# Fitting M4 bolts to the flaps control

**FLAP CONTROL - 368 - COMMANDE DE VOILETS**

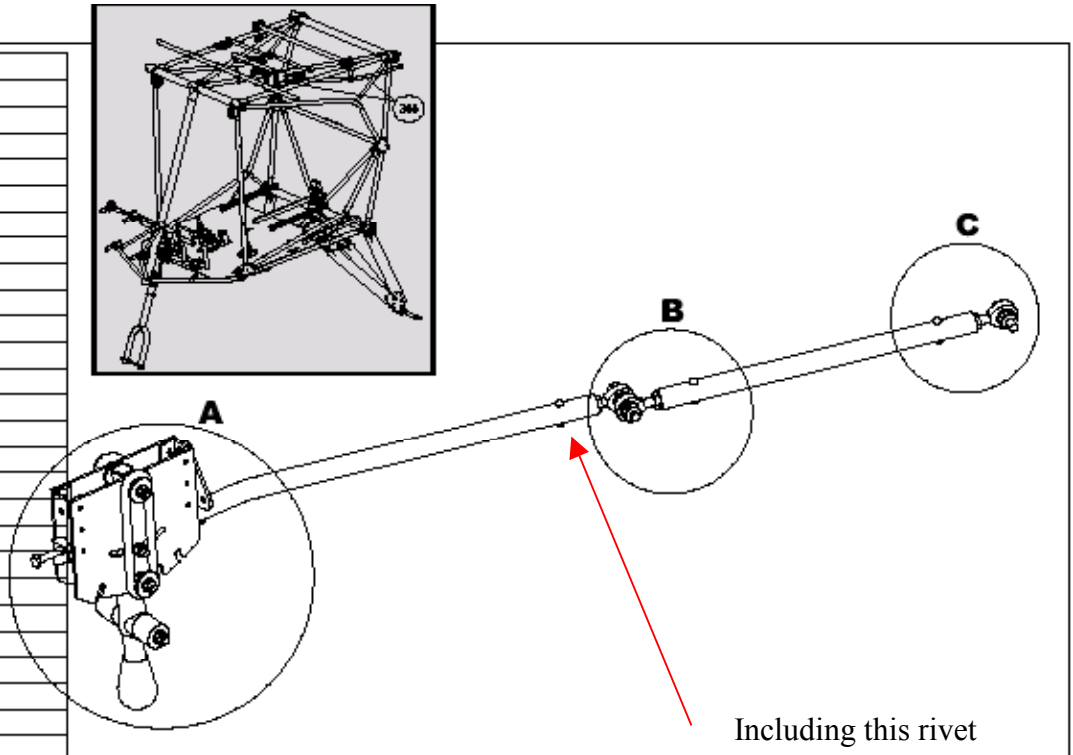
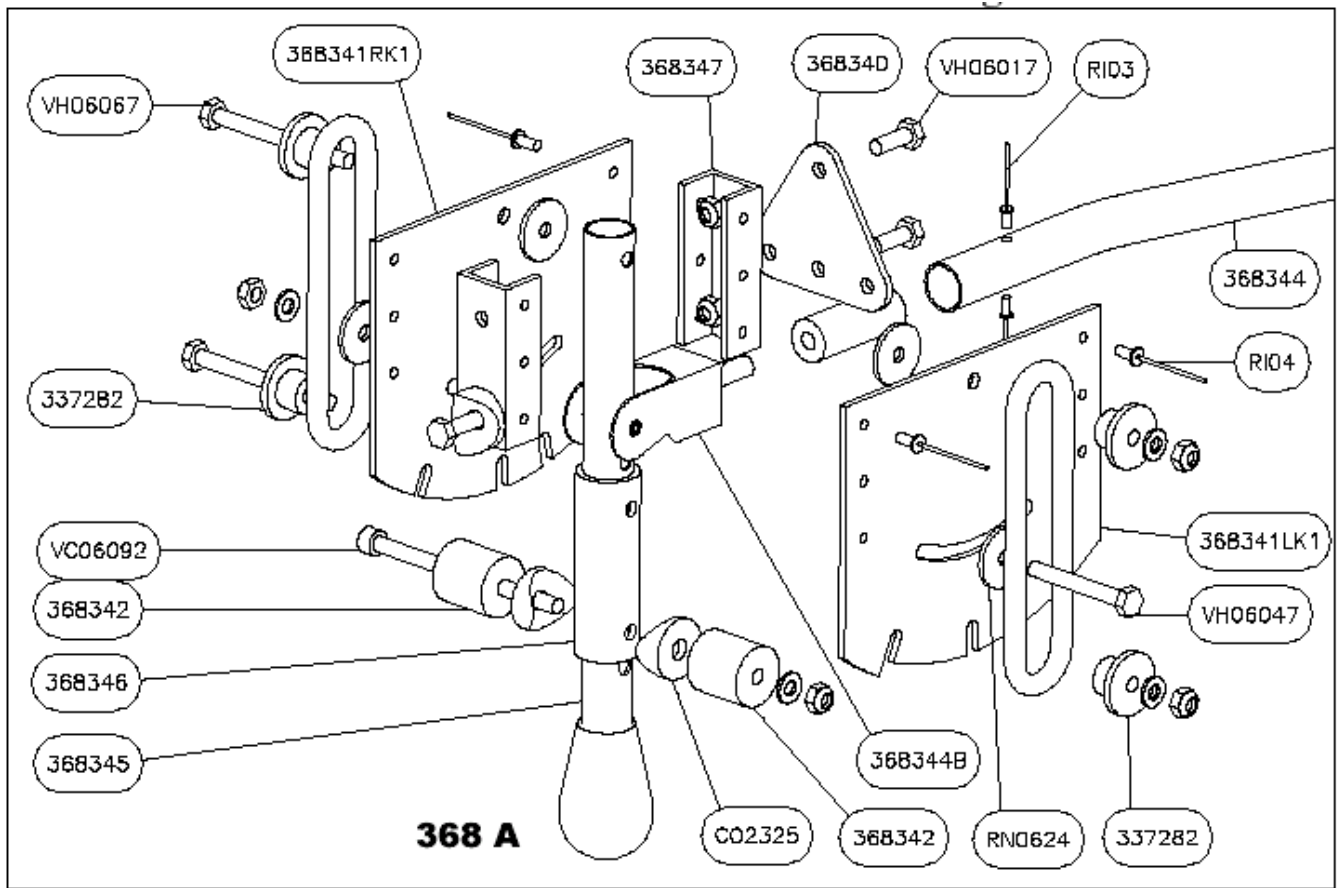
The 2 rivets R103 in diagram 368 A have to be replaced by 1 M4 bolt and nut, as well as the pair shown in the diagram below.

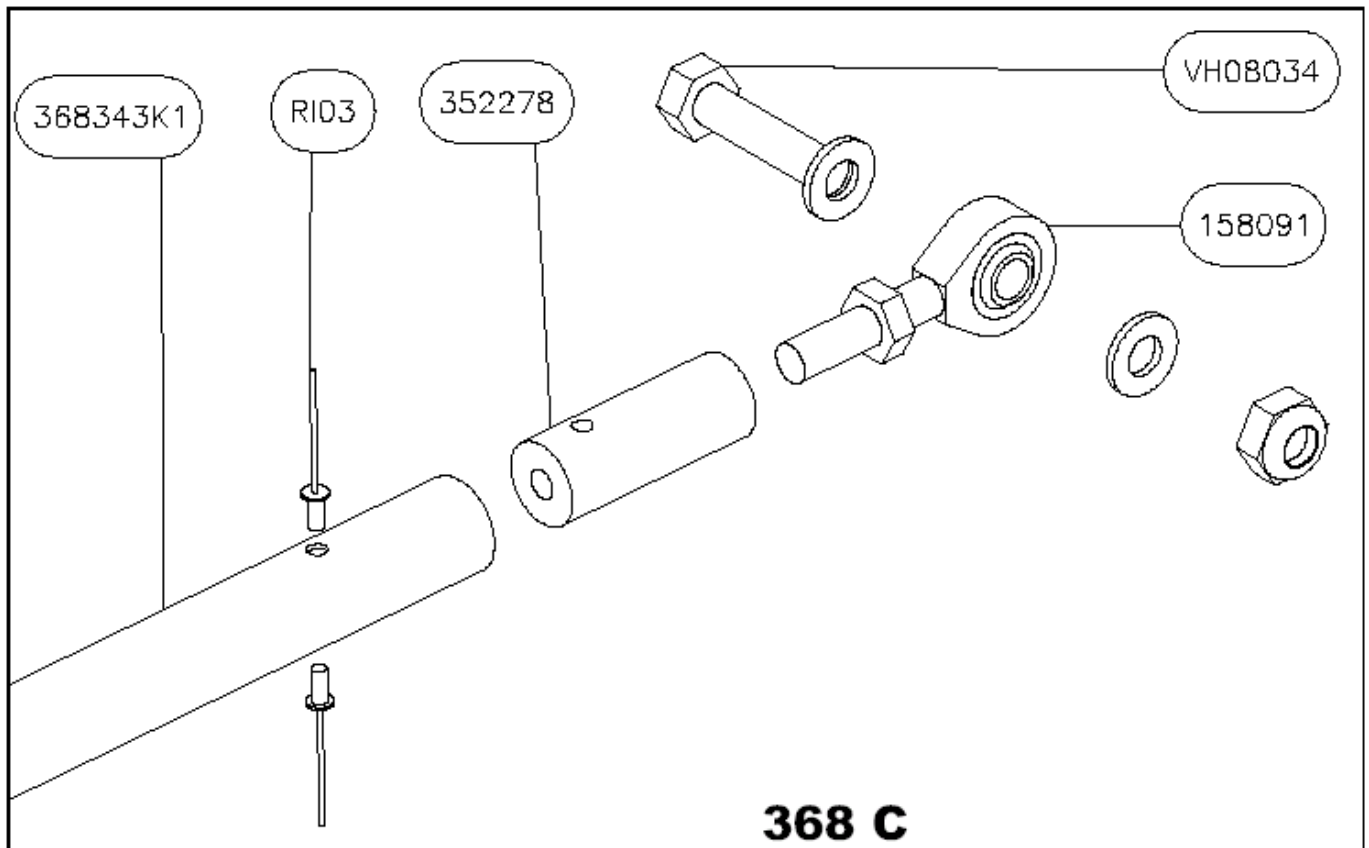
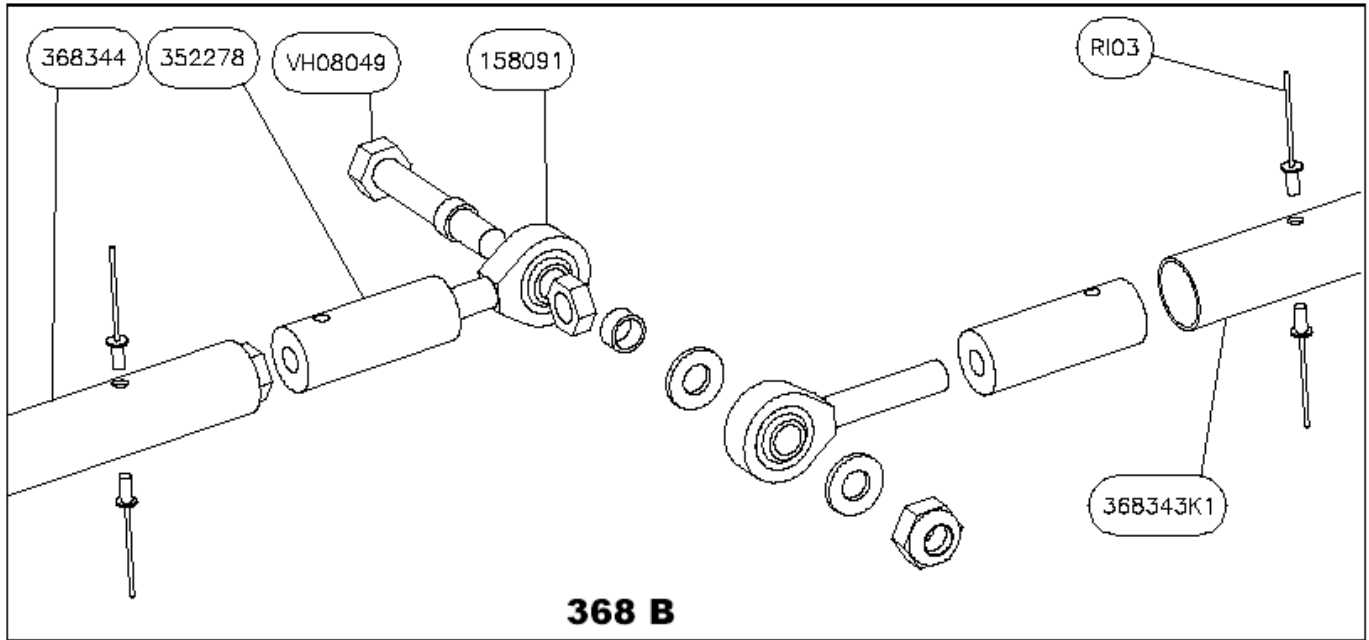
The 4 rivets R103 in 368B and the 2 rivets R103 in 368C have to be replaced by single M4 bolts and nuts through the tubes to hold the aluminium fittings

Note as well as the rivets on the flaps control arm on the right side of the cabin will also need to be replaced by M4 bolts and nuts.
